ASSISTANCE TO THE MUNICIPALITY OF DAMASCUS  
IN THE CONSTRUCTION OF A COMPOST PLANT .

SI/SYR/79/802

Technical Report \* .

Based on the work of John Marriott  
Consultant in Compost Production

# AYN TERME

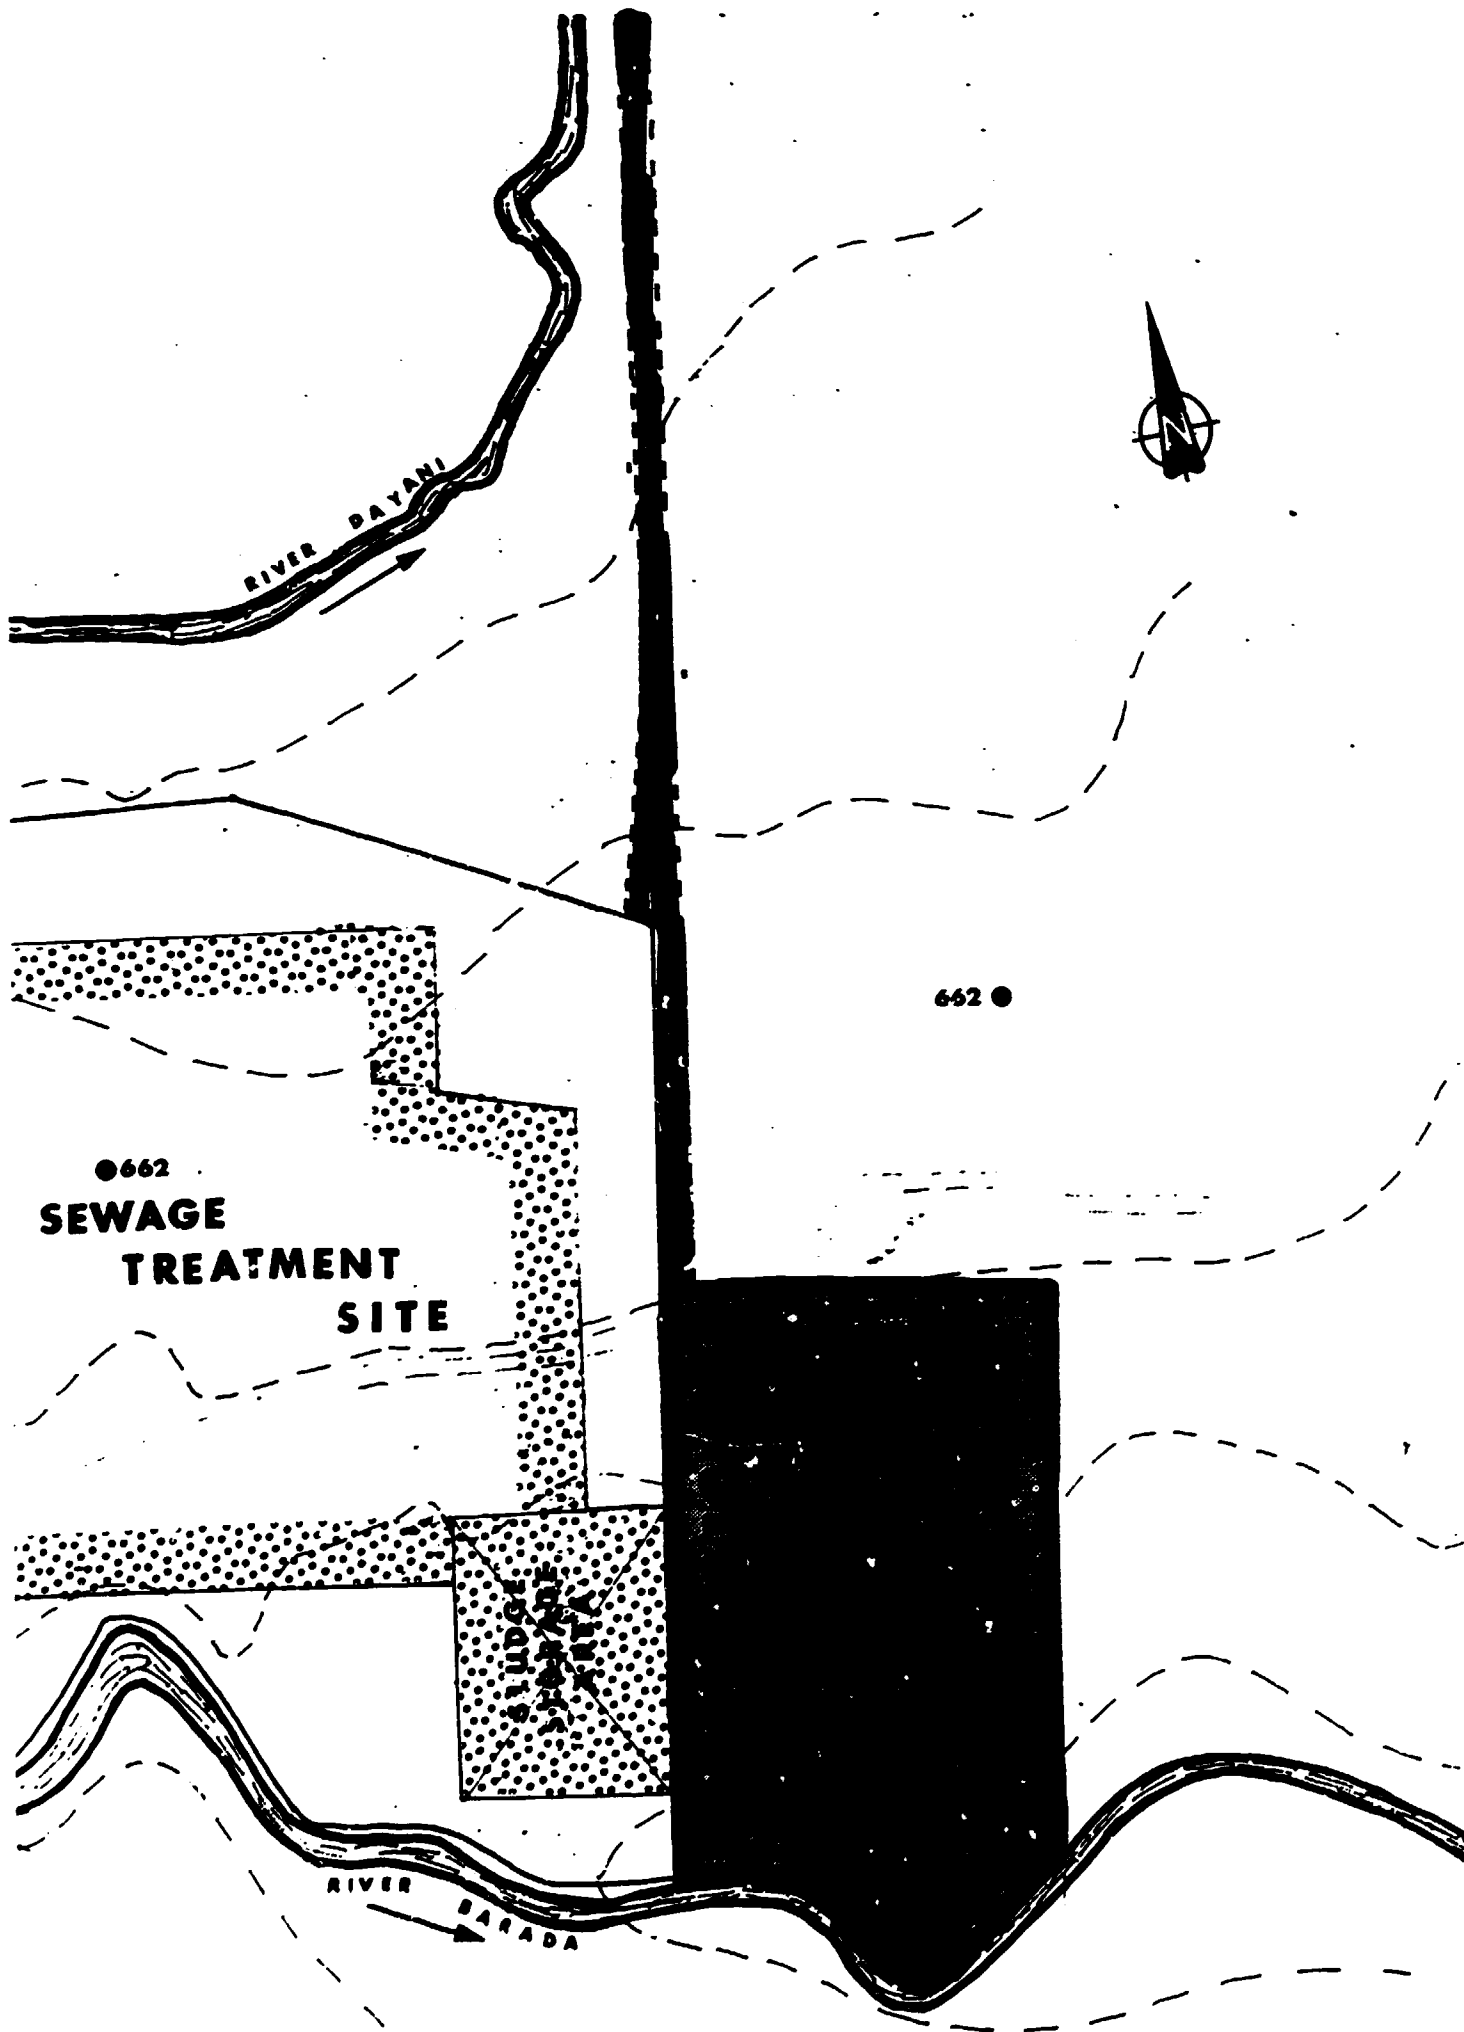
- 3.5. The site is without a satisfactory vehicular access at present. The sewage works proposals provide for vehicular access to that site at the north-west corner of the site and at a point 1.2 kilometres west of the composting site. There is available space in the sewage works site clear of operational areas along its northern boundary where an interconnecting road between the proposed sewage works access and the composting site could be constructed. For operational reasons however this is not very desirable.

- 3.6 Preliminary outline proposals exist to provide a vehicular access to the composting site aligned in a north-south direction and connecting with the Damascus-Sakba Road which is situated about 900 metres north of the composting site. This proposal has considerable merit and it could CONVENIENTLY BE USED JOINTLY BY THE SEWAGE WORKS AND THE COMPOSTING PLANT.
- 3.7. Both plants will generate a considerable amount of vehicular traffic. The composting Plant at least 300 vehicles per day and the sewage works at least 100 vehicles per day. The details are:
